Re. Further Advice Notice (OW/2022/5330)

Project No: 16552

Project Title: Gainsborough Lodge – Stage 1

This letter provides a response to the the Further Advice Notice dated 12/04/23.

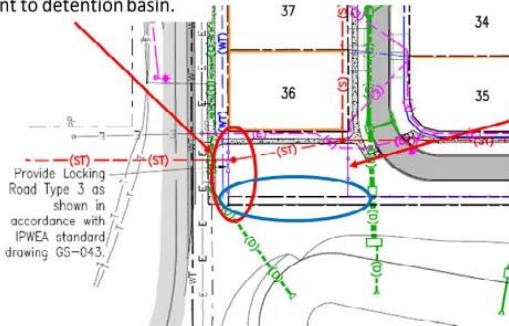
2.2	Aspect of Development:
	The size of the bio-retention basin is confirmed as 1,380m ² for stage 1-4 but the size of the basin for stage 1 has not been provided. Until a mechanism is in place for the bio-retention basin to be constructed at stage 4, the development permit will need to condition construction of a bio-retention basin to service stage 1 with an advice note to the effect that Council would consider deferral of construction of the stage 1 basin until stage 4 of development.
	Further Advice
	Please confirm the size of the Stage 1 bio-retention basin and update the drawings to show the area and location of the stage 1 basin.

The bioretention area can be bonded within of Stage 1 Operational Works approval. It would be reasonable for the Stage 1 portion of the bioretention area to be bonded based on a percentage of total basin catchment area. The Stage 1 area (including Hursley Road and draining reserve) accounts for 48 percent of total Stage 1-4 area. Therefore, for the purposes of defining a bond amount, a bioretention filter area of 662.4m² can be adopted.

Conditioning early construction of the bioretention basin before the upstream building catchment is mature is not in line with Council's PSP, as outlined in our RFI response letter dated 20/03/23. Additionally, conditioning as proposed with an advice note can complicate off-maintenance as we understand under advice notes are not legally binding.

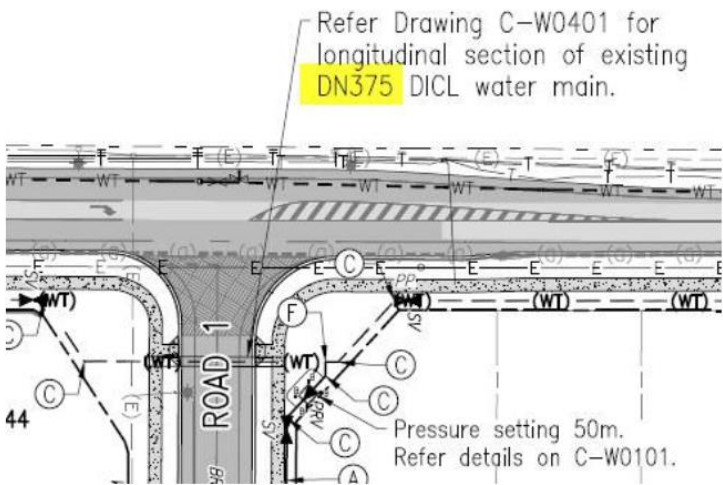
4.2	Aspect of Development:
	<p>Manholes 4/A, 4/B, 4/D, and 3/E are proposed to be only constructed as end of line DN100 property connections. These need to be constructed with DN1050 maintenance structures.</p>
	Further Advice
	<p>Please re-submit amended drawings to show full maintenance structure construction for MH4/A, 4/B, 4/D, and 3/E.</p>

This advice relates to Information Request Item 5.4. The response provided with RFI response letter dated 20/03/23 is as follows:

"End of lines 4/A, 4/B, 4/D and 3/E avoid future road crossings and reduces rework on Council's behalf. While manholes are ultimately required at end of lines 4/A, 4/B, 4/D and 3/E, finished surface levels of future stages may change. Plugged end on lines are provided as future levels are unknown.

Manholes at these locations were also discussed at an RFI meeting held with Council 23/11/22. Constructing manholes now creates more "live works" for Council with future stages. Manholes would be in effect constructed twice.

We request this advice is omitted.
